<b>Technical Bulletin</b>		<b>Model</b> <b>6 Cyl.</b>	<b>Group</b> <b>1</b>
<b>Subject</b>  <b>Oil Fill Pipe Bellows</b>		<b>Part Identifier</b> <b>1715</b>	<b>Number</b> <b>9603</b>

**Models Affected:** **911 Turbo Model Year 1996**

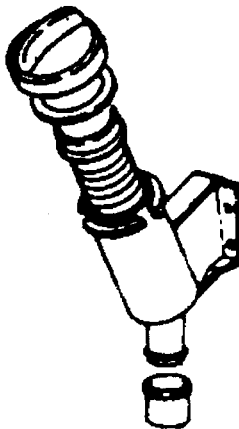
**General Information:** As of June 1996 production, 911 Turbos have a longer oil fill bellows installed in the oil fill pipe. The new oil fill bellows is 40 mm longer than the former version and improves the oil filling characteristics of the engine.

The former version oil fill bellows can easily be removed by pulling it out of the oil fill pipe. When installing the new version oil fill bellows, place the end that is wider and slightly curved in the oil fill pipe first and press into the fill pipe.

**Parts Information:** 993 207 363 50 Oil Fill Bellows (approx. 210 mm - 225 mm long when stretched)
